Subject: Issuance of Amendment No. to Facility Operating License NPF-9
and Amendment No. to Facility Operating License NPF-17 - McGuire
Nuclear Station, Units 1 and 2 (TACS 65906/65907)

Amendment No. 78
License No. NPF-9

Amendment No. 59
License No. NPF-17

SAFETY EVALUATION BY THE OFFICE OF NUCLEAR REACTOR REGULATION
RELATED TO AMENDMENT NO.78 TO FACILITY OPERATING LICENSE NPF-9
AND AMENDMENT NO. 59 TO FACILITY OPERATING LICENSE NPF-17

Figure 3/4 7-1
Nuclear Service Water System

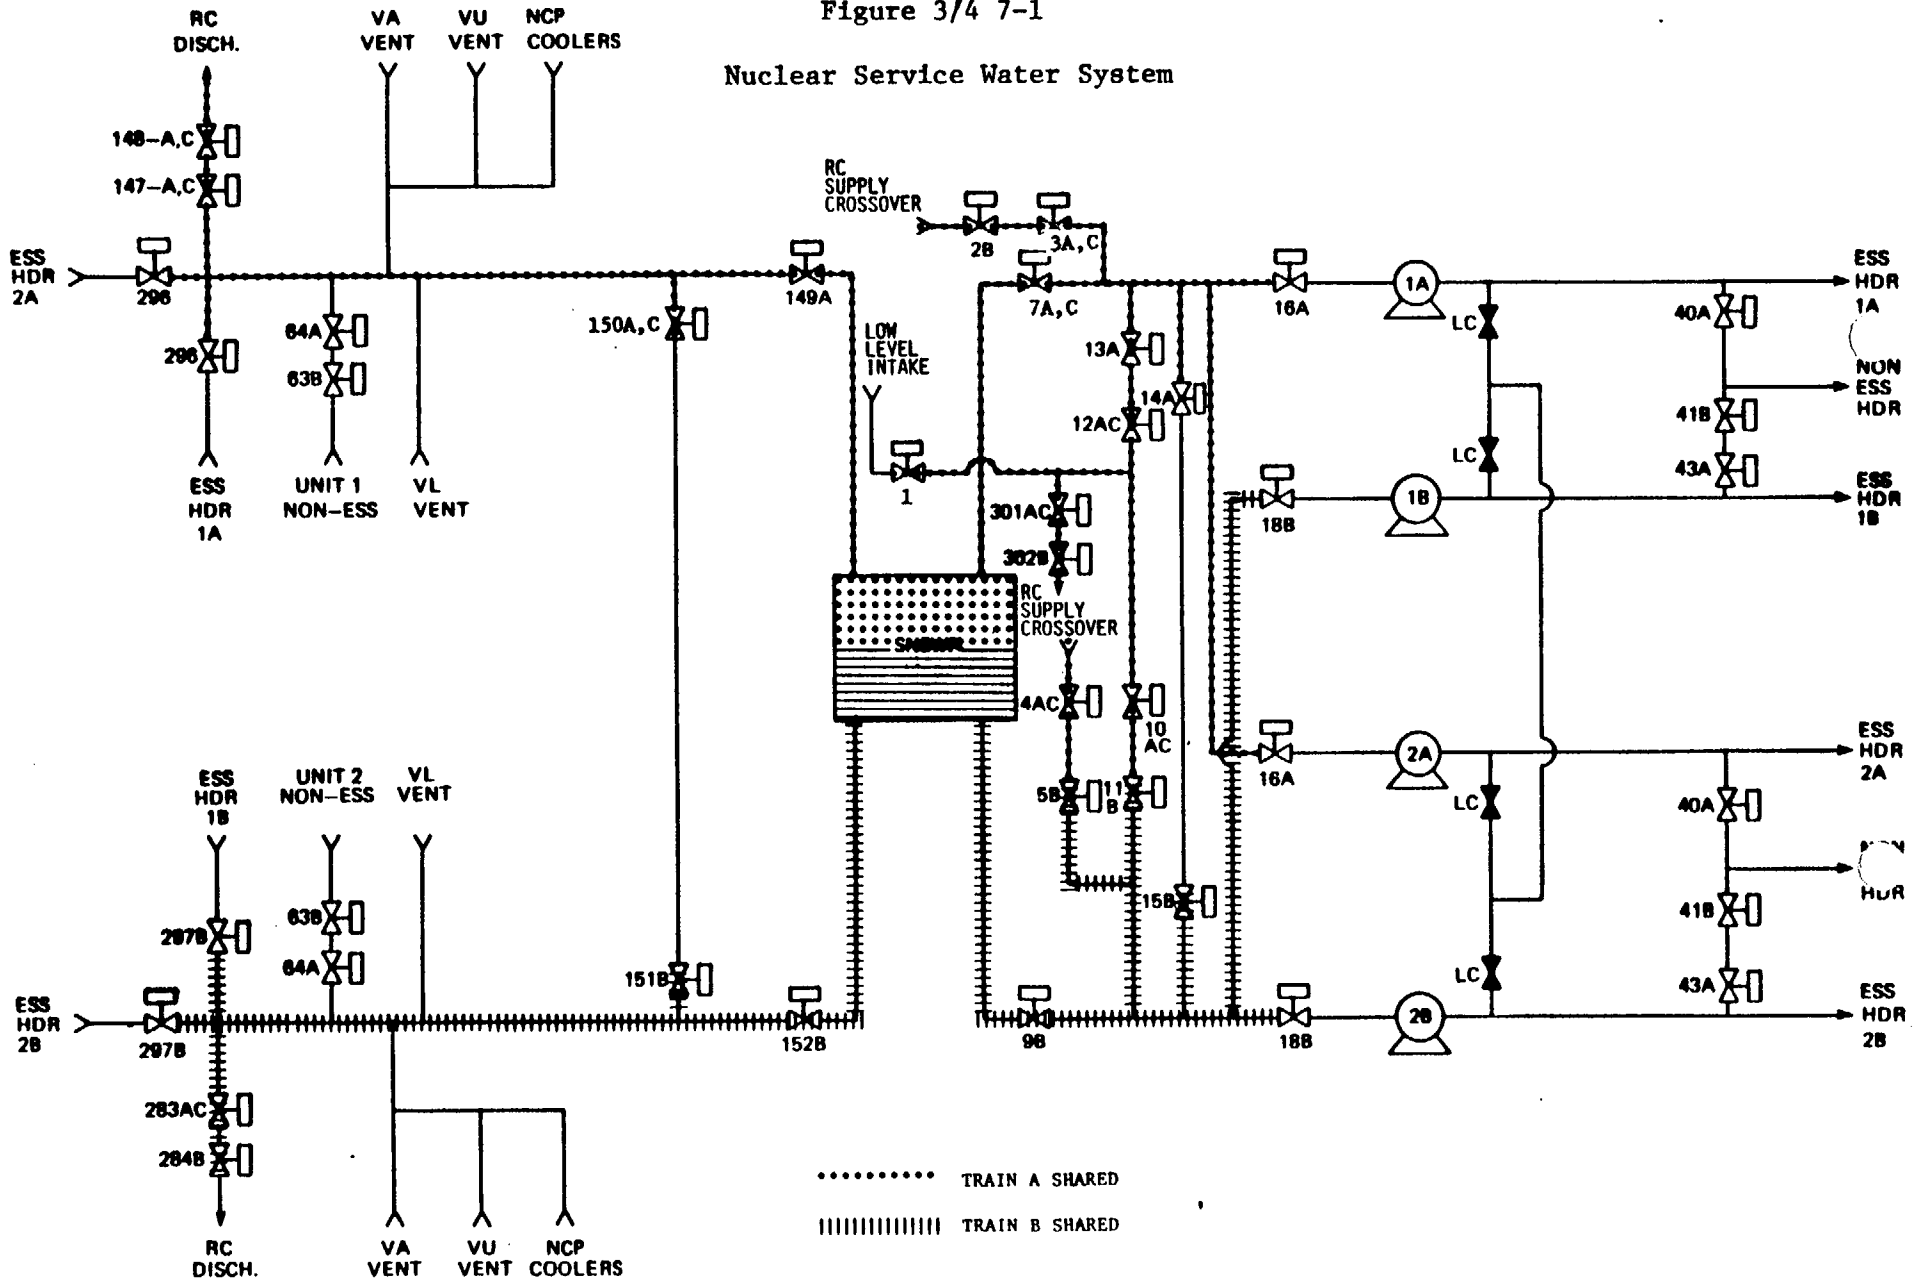
The amendments change Technical Specification 3/4.7.4 "Nuclear Service Water System" and its Bases to reflect that portions of the system are shared between the two McGuire units, but that the system is not shared in its entirety. Minor relabeling of valves on page 3/4 7-11a was also done in accordance with my telephone discussion with Mr. Jerry Day of your staff. The amendments are effective as of their date of issuance.

Portions of the Nuclear Service Water System are common to both units. These shared portions of the system are indicated on Figure 3/4 7-1 and common valves are listed in Table B 3/4 7-1 and include common suction piping and cross-connect piping as indicated on the figure.

therefore, applies to only one unit. The second action statement, item (b) of the revised specification, addresses the shared portions of the RN system as defined by the new Figure 3/4 7-1. It requires that with only one of the shared portions of the loop OPERABLE, both portions are to be returned to an OPERABLE status within 72 hours or both units are to be in hot standby within the next 6 hours and in cold shutdown within the following 30 hours.

During its review of the licensee's submittal, the staff noted a labeling discrepancy between Table B 3/4 7-1 and Figure 3/4 7-1. In the table, the valve in the low level intake supply lines to the RN system was labeled ORN-1 while the valve of interest on the drawing did not have an identifying number. Also in the table the valves identified as ORN-3A, C, ORN-7A, C and ORN-150A, C did not have the "C" designation in Figure 3/4 7-1. Because these letters "A" and "C" have power supply connotations and since the figure is to be part of the TS, the staff concluded it should be corrected to agree with Table B 3/4 7-1. In a subsequent discussion with the licensee, the licensee agreed that the proposed TS Figure 3/4 7-1 should be revised such that the valves numbered 3A, 7A and 150A become 3A, C; 7A, C and 150A, C while the single unnumbered valve between the low level intake and the RN system should be designated 1, to agree with Table B 3/4 7-1 where it is identified as ORN-1. Therefore, these administrative changes have been made.

The Commission made a proposed determination that the amendments involve no significant hazards consideration which was published in the Federal Register (52 FR 34003) on September 9, 1987. The administrative change subsequently made by the NRC staff regarding the labeling of certain valves in TS Figure 3/4 7-1 does not change this determination or its basis. The Commission consulted with the state of North Carolina. No public comments were received, and the state of North Carolina did not have any comments.
